# WORKPLANS

**RE: Corrective Action Plan Amendments**  
Vanguard Natural Resources LLC  
**ABO F-31 SWD**  
UL F Sec 31 T 16S R 37E  
NMOCD Case Number: 1R 488

## ABO F-31 SWD CAP

**Figure 1** – Proposed monitor well locations (**red circles**) and soil boring locations (**blue circles**).

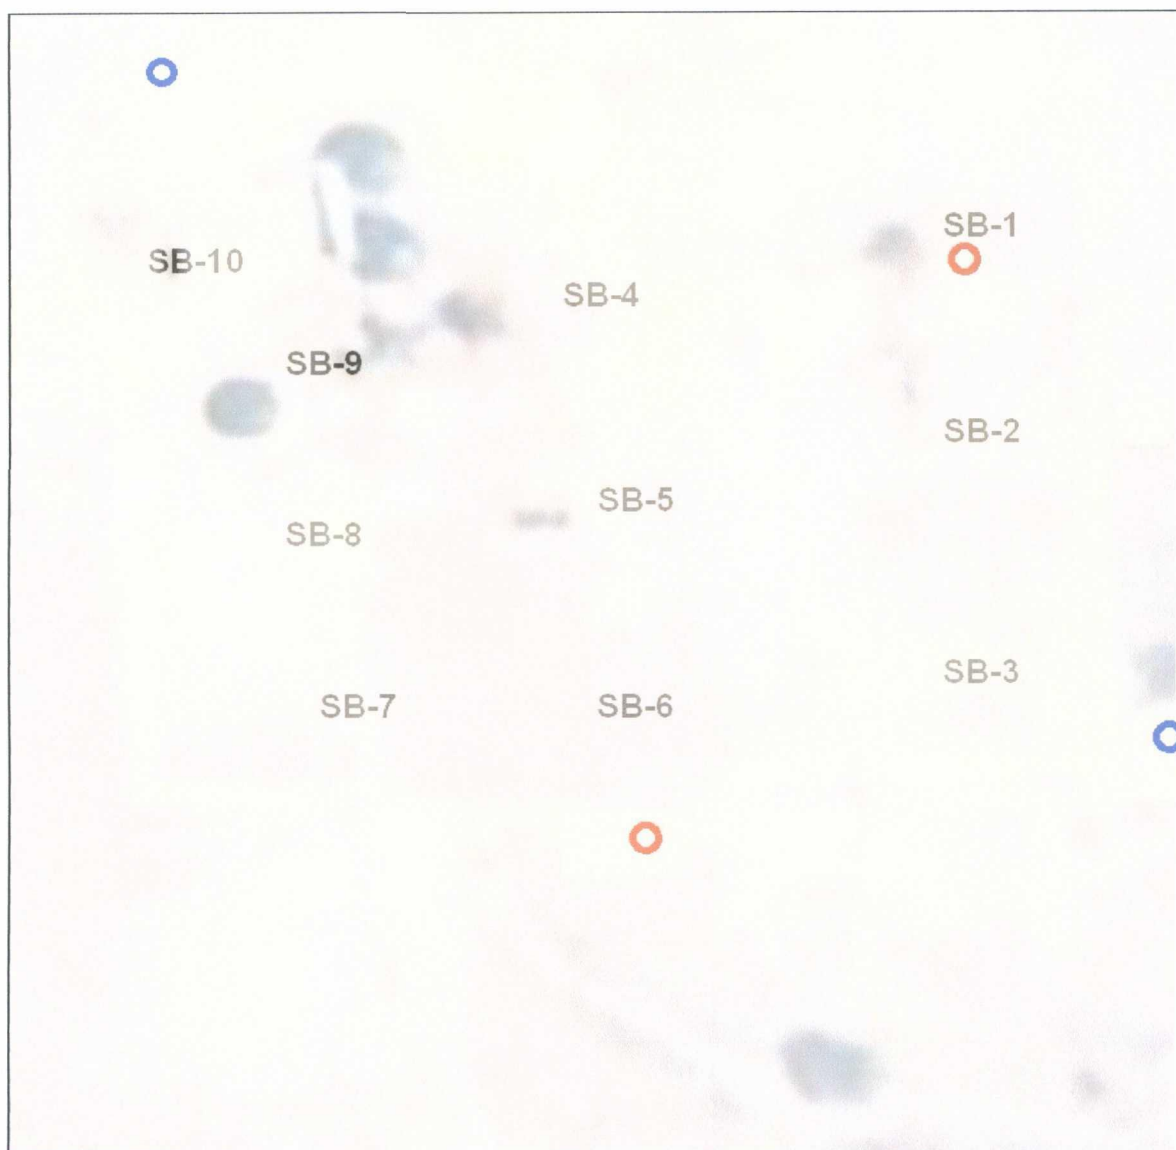
1. Vanguard shall install two groundwater monitor wells per State of New Mexico standards, as shown in Figure 1. (Also see Figures 3 & 4 in the CAP).
2. Vanguard shall initially sample and analyze the monitor wells for chloride, TDS and BTEX within 90 days of monitor well installation. Subsequent sampling and analysis, if warranted, shall be determined in consultation with NMOCD.

4. Vanguard shall sample soil material from two additional borings (again, from shovel cut samples) outside the immediate perimeter of the SWD facility (Figure 1) to better delineate the lateral extent of residual chlorides and petroleum hydrocarbons. The initial target depth for these borings will be 90 ft bgs but may be truncated if chlorides decline sufficiently (three declining samples with the
